Ref: FSN 2020-09-21 AS;STK

## FIELD SAFETY NOTICE – Redyrob® Trans Plus

Article	Material number
Redyrob® Transplus Closed Wounddr. System	5526604

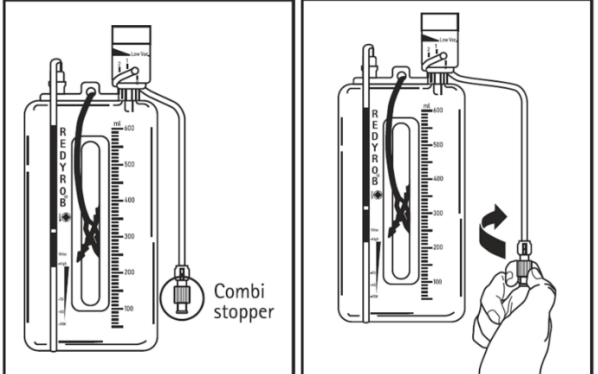
By detailed evaluation of our post-market surveillance activities it has been identified that an update of the instructions for use is necessary in order to highlight the need for the removal of the red combi stopper before using the device.

The combi stopper is a component closing the tube and ensuring the vacuum tightness of the product, when the vacuum regulator is not in zero position. If not removed before usage, it prevents flow of wound secretion and therefore posing the risk for a delayed therapy.

In order to inform customers of the correct handling the Instructions for Use were updated. The updated version contains the respective instruction in writing and as picture, to ensure an adequate description.

Text	Picture
<p>2. Remove the red combi stopper or secretion bag from Luer Lock of the Redyrob Comp.</p> <p><b>CAUTION: Do not connect anything to the red combi stopper!</b></p> <p><b>The combi stopper prevents wound secretion flow.</b></p>
